Addendum #3

IFB No. 130792 - Joint Forces Training Base Lexington Drive and Lot A
Repairs Joint Forces Training Base - Los Alamitos, CA
9/2/2026 at 2:00 PM

RFI Responses

Project
JFTB LEXINGTON DRIVE ENTRY

Attachment 2
Distance to Drop Material
Site Map

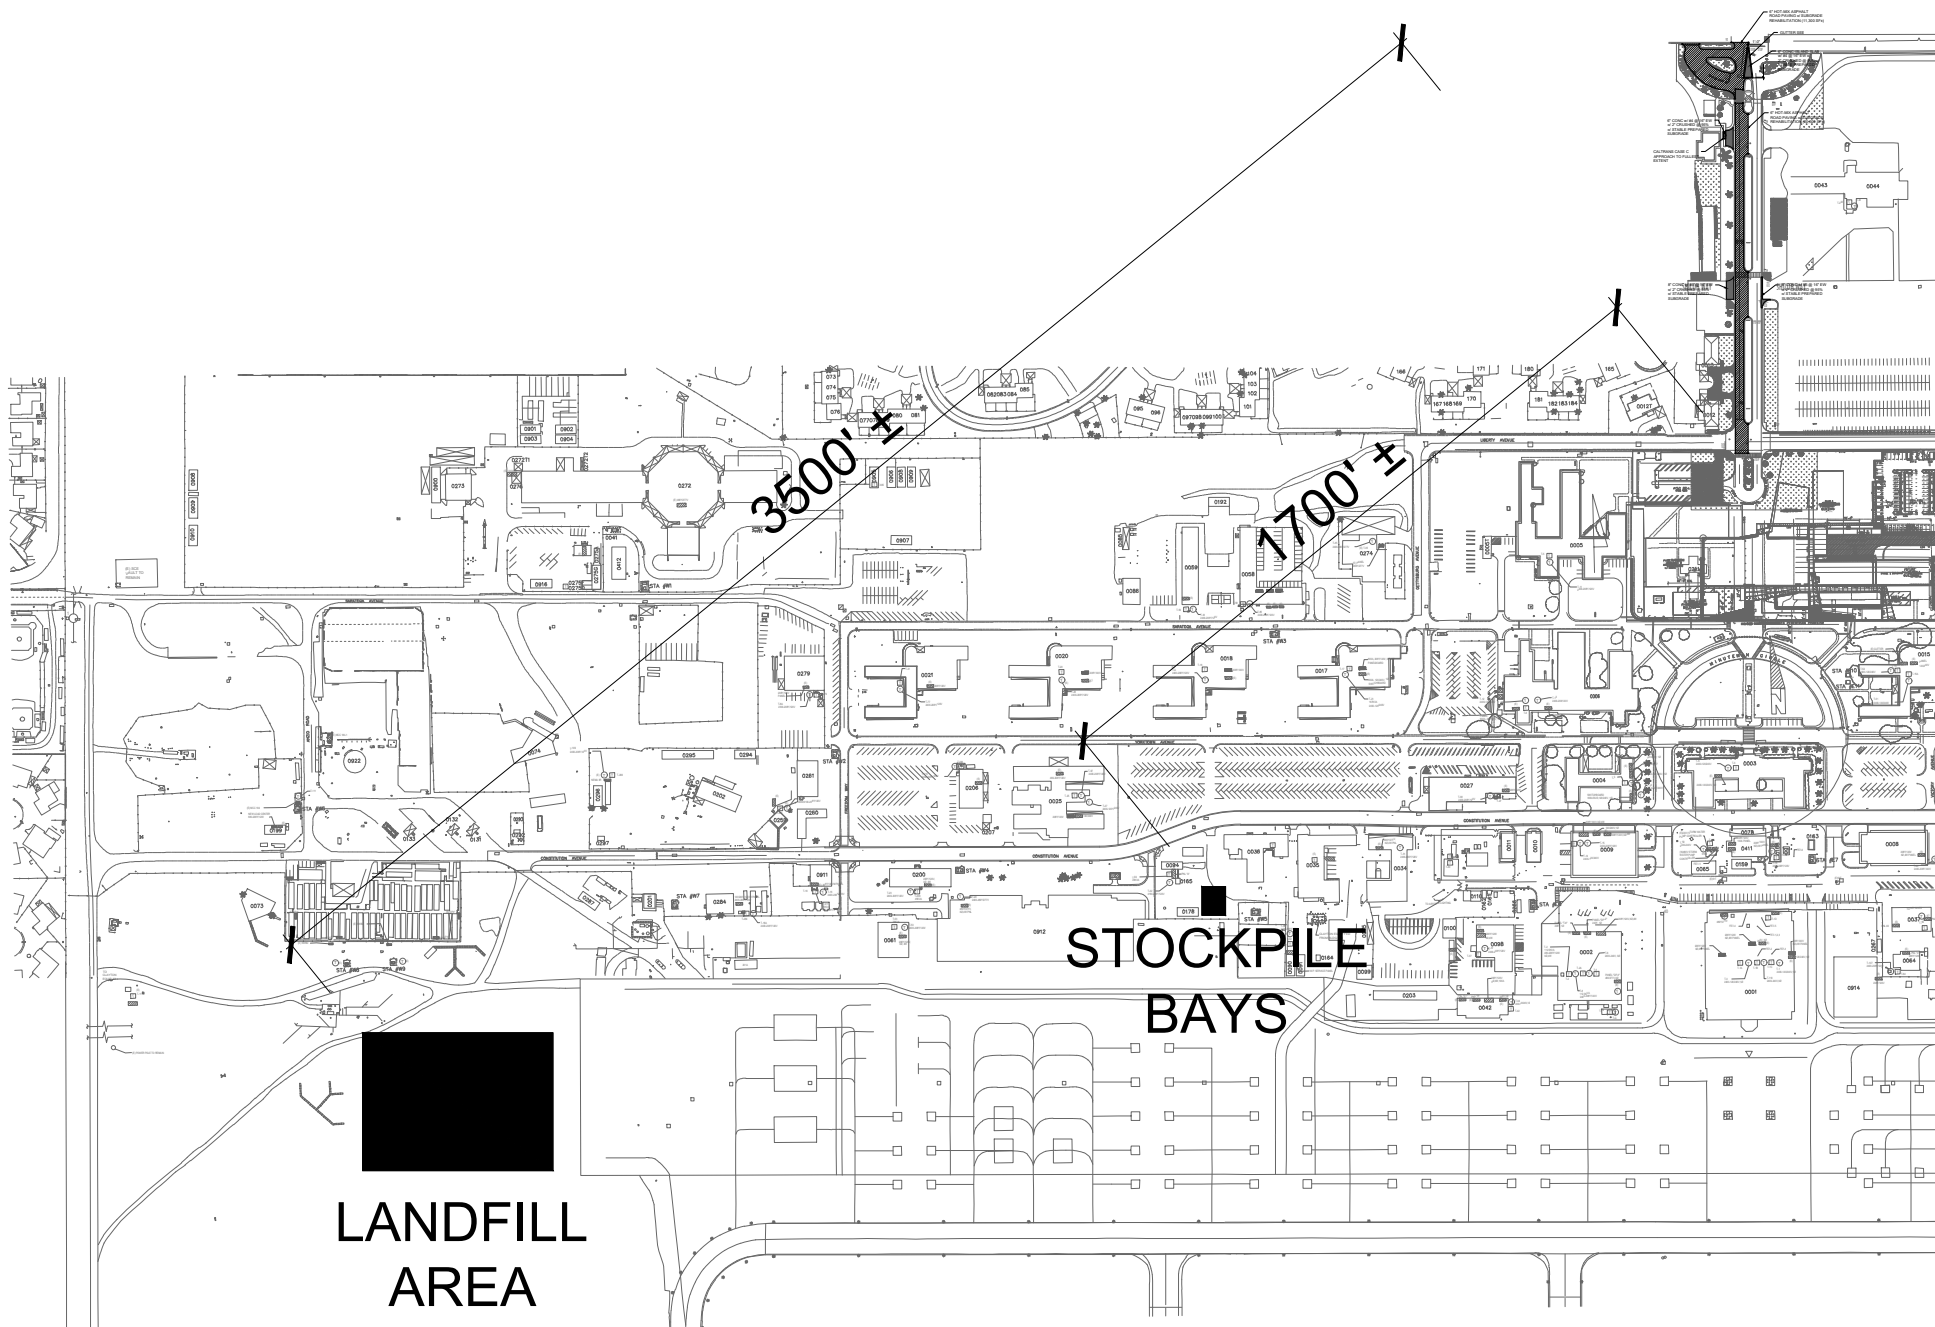
Native Aggregate base – Reuse at contractors' discretion, excess on site at JFTB department of public works (DPW) stockpile material areas in concrete barrier (see attached)

1 ASPH - ROAD SECTION

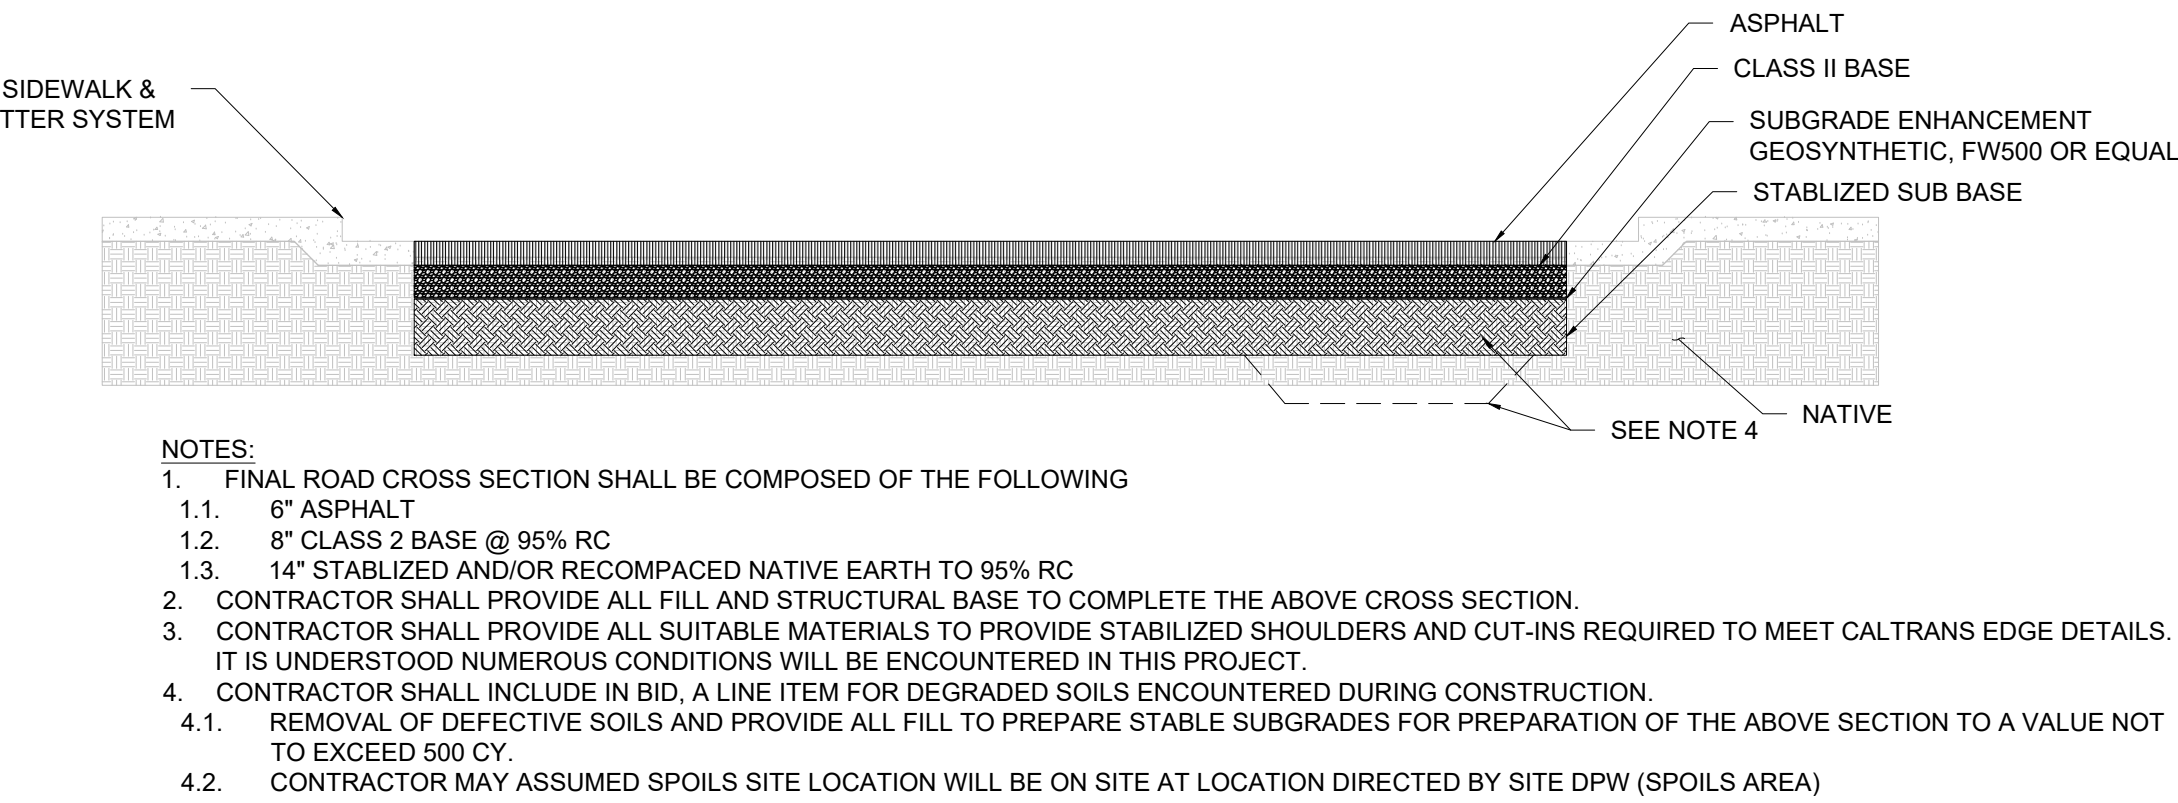
1. Regarding Attachment 3 (Rate Sheet) in the IFB Addendum 2, Description of the Base Bid: Please clarify whether the specified 22" excavation depth is measured from the top of the existing asphalt pavement surface or from the bottom of the existing asphalt pavement layer.

6. According to Detail 1 on Sheet C2 of Addendum 2 plans, notes 4, 4.1, and 4.2, please describe what materials can be disposed of onsite with respect to: asphalt millings, native aggregate base, broken concrete, and excavated soils that are not to be reused.

7. Please identify the bid item or line item where the scope associated with Note 4, Detail 1 on Sheet C2 is to be included for bidding purposes.

Answer: Please see detail 1/sheet C2. 28 inches total (6.8,14). If [E] AC 4", 5" or 6", contractor still going 28" from top of the pavement to achieve final cross section

Answer:

Concrete – disposed of offsite/recycler

Asphalt millings/tailings – disposes of offsite/recycler

Excavated soils – clayey or other non-reusable, dispose at on locations directed by JFTB DPW. Per Note: Contractor to provide line item \$ amount, CMD/IOR will work with contractor for takeaway as project proceeds. Any excess quantities will be credited back to government at close of project. Contractor remains responsible for supplying any balance required to meet the final road cross section

Answer: This work will be included in the base bid, with a limit not to exceed 500 CY. The final cost will be adjusted downward if the total volume of defective soil is less than 500CY.

2 CONC SLAB SECTION - VEHICLE USE

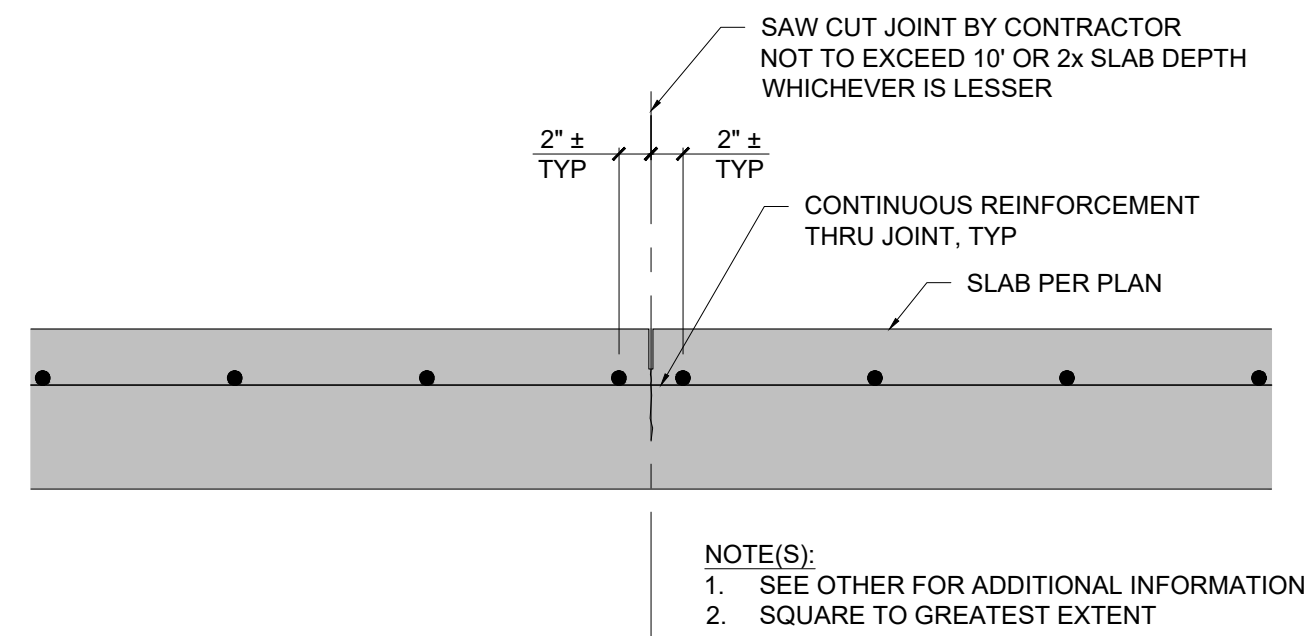
3. Regarding Detail 2 on Sheet C2 of the Addendum 2 Plans: Please clarify the required concrete cover dimensions for the reinforcing steel on a 6- inch Slab including:

- Top reinforcement concrete cover (distance from top of slab to top of rebar)

- Bottom reinforcement concrete cover (distance from bottom of slab to bottom of rebar)

4. What depth of scarification is specified in Detail 2 (Sheet C2, Addendum 2 plans) for subgrade preparation in stable soil conditions?

Answer: 2"

Answer: 3 1/2 +/-

Answer: CMD requires contractors to repair area; mix, dry, till, etc, these areas for application of base course. If contractors elect to remove soil under note 4, contractor shall remove soil to the spoils area (see attached). If contractor

determines further manipulation of soil strata is achievable to reach stable soil condition, contractor to supply man hours, machinery, etc. to complete such work.

Sheet Title
PLAN_SHEET

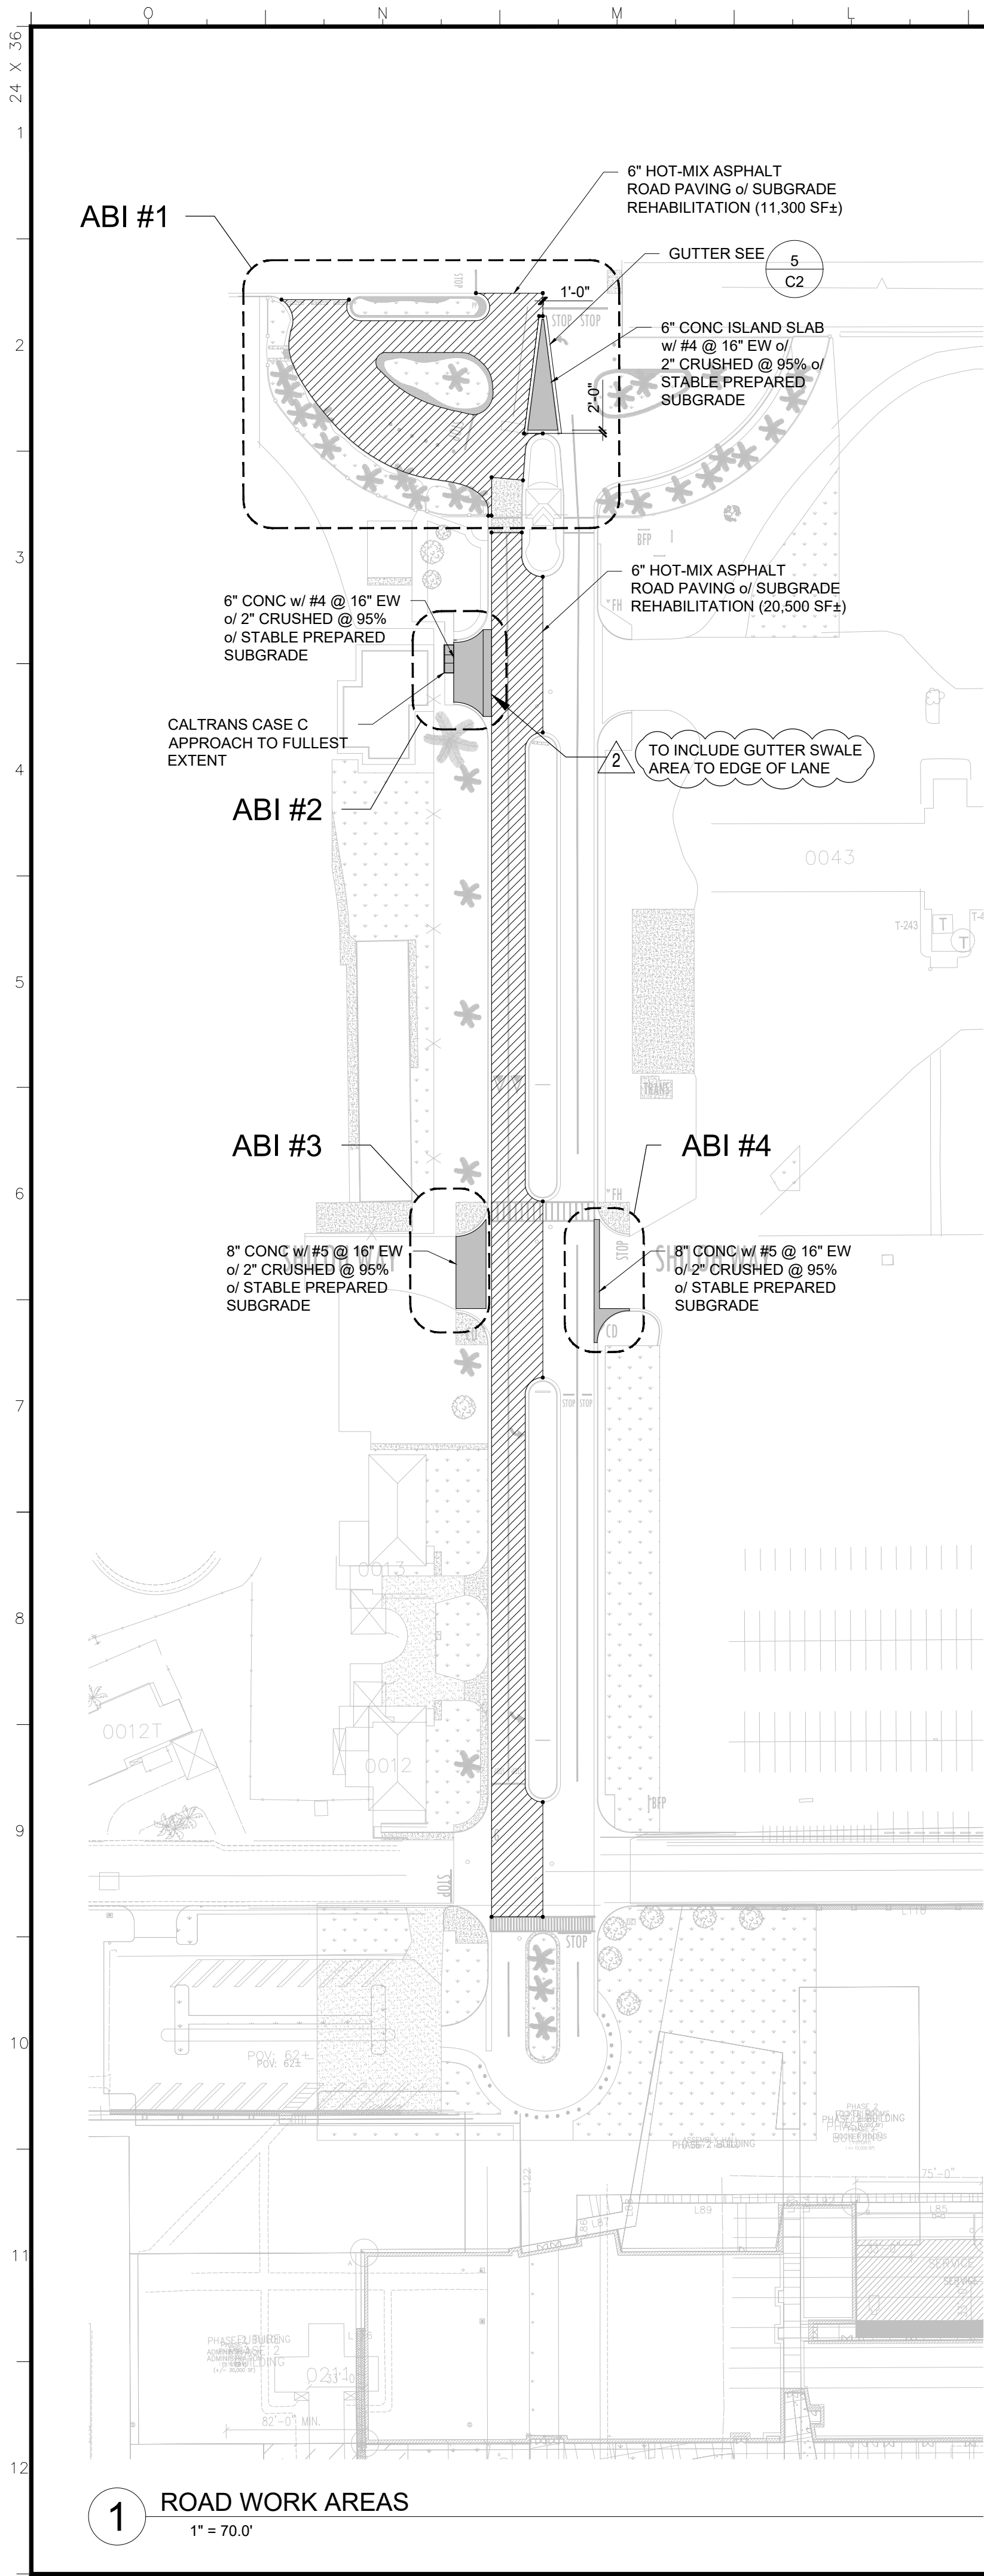
5. Sheet C3 specifies 2-inch crushed rock. Confirm whether this is equivalent to Class 2 Aggregate Base or identify the required material specification if it is a different product.

Answer: Recycle concrete is ok, not to exceed 3/4- inch diameter max. If contractor decides to place class 2 because such an amount is already being delivered to site as a result of asphalt work – contractor may use class 2.
